ATTACHMENT 1

SUMMARY OF PROPOSED CHANGES

## 7.1 ORGANIZATION, REVIEW AND AUDIT-ADMINISTRATIVE CONTROLS

FORT ST. VRAIN NUCLEAR GENERATING STATION  
ADMINISTRATIVE AND DEPARTMENTAL MANAGEMENT ORGANIZATION CHART

FIGURE 7.1-1

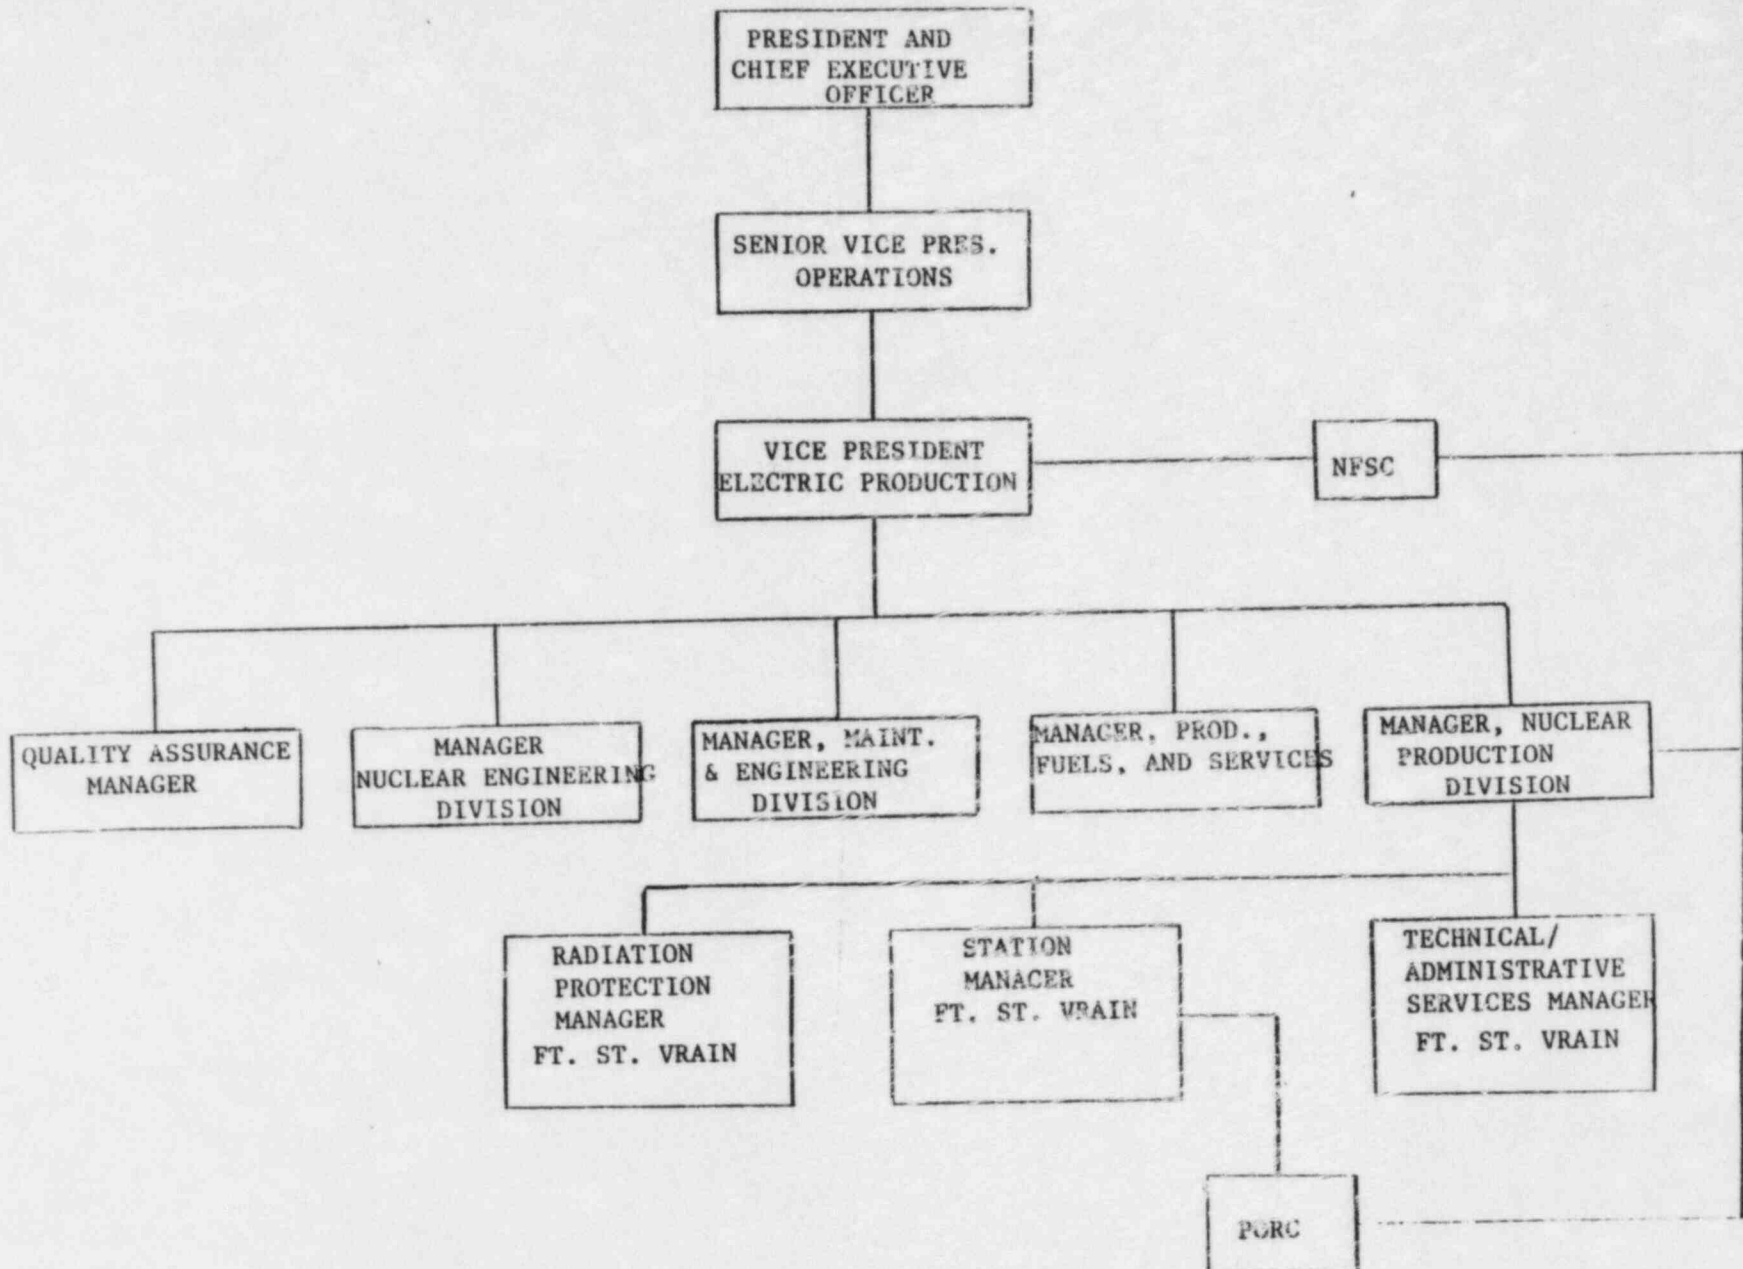
- a. In all matters pertaining to operation and maintenance of the plant and to these Technical Specifications, the Station Manager shall report to, and be directly responsible to, the Manager, Nuclear Production. The Administrative and Departmental Management Organization is shown in Figure 7.1-1.
